Delegated Report

Prior Approval

Planning Application No: 20230767

Description: Application for a determination as to whether prior approval is required for conversion of existing agricultural storage buildings north of Hill Farm House to 3no. dwellings, including the insertion of windows, glazed doors, first floors and roof lights to ensure all habitable rooms are naturally lit.

Figure 1

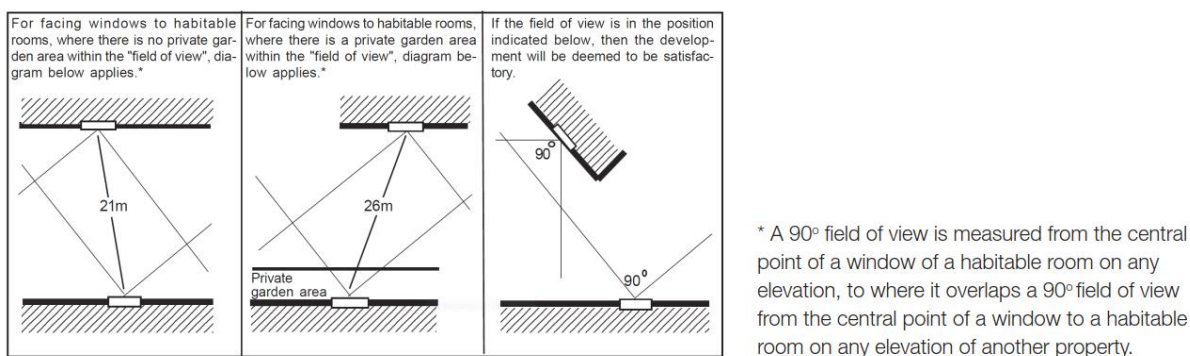
- The south elevation of the building facing the adjoining neighbours would have a distance of between 5.8m and 15.6m which would be quite significantly below the required privacy distances. The Residential Layout Guidelines applies appropriate privacy distances which are included below
